# Staff Report

## Site Plan Review

SP-07-24

To construct 8 multiple dwelling units with associated site improvements. The proposed apartment building will be two stories in height and consist of eight one-bedroom units.

Sheet **C1.2**  
 SCALE: SEE BARSCALE

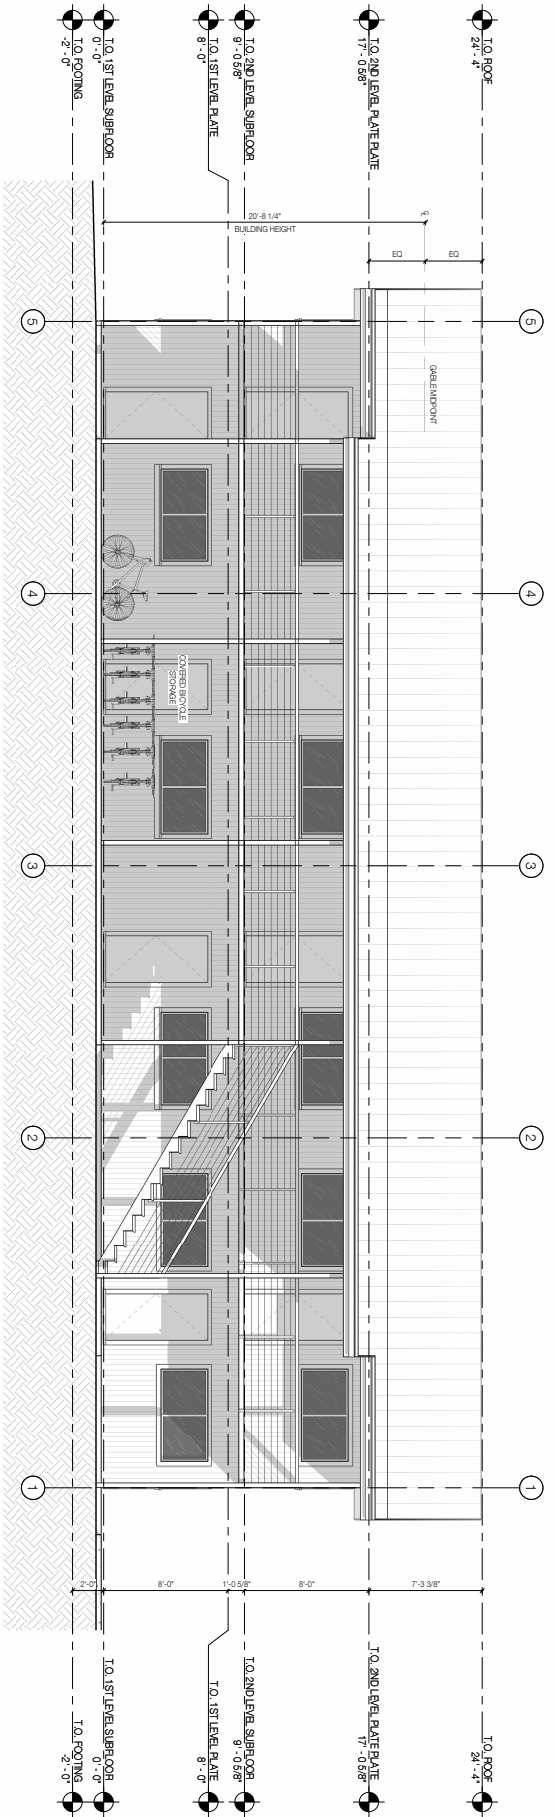
*In addition, sheet C1.2 states that the minimum setback from a 2-story building is 20 feet and the minimum setback from storage is 10 feet.*

- The written narrative does not reflect the current maximum parking standards, therefore, the maximum parking allowed is calculated incorrectly. The vehicle parking summary on page C1.2 of the civil plan set references the correct standard, but the maximum parking is incorrectly calculated.

- *Page C1.2 of the civil plan set states the total width of the standard covered bike parking spaces will be 8.5 feet and the area depicted on the drawing is 10 feet. ADC 9.030-2 requires a space width of 1.5 feet for side-by-side spaces. If 6 standard bicycle parking spaces are required, the standard bicycle parking area would be 9 feet wide.*

As depicted in the revised civil site plan, the proposed trash enclosure has been moved from the northeast to the southeast corner of the parking lot to allow for a 5-foot-wide landscape planter bays on either side of parking stalls 1-3. Landscape planter bays 10-foot-wide or greater are provided on either side of parking stalls 4-10.

The parking lot back up area is at least 5-feet from the north property line and excluded from the required parking lot buffer requirement per Table 9.120-1, note 3.
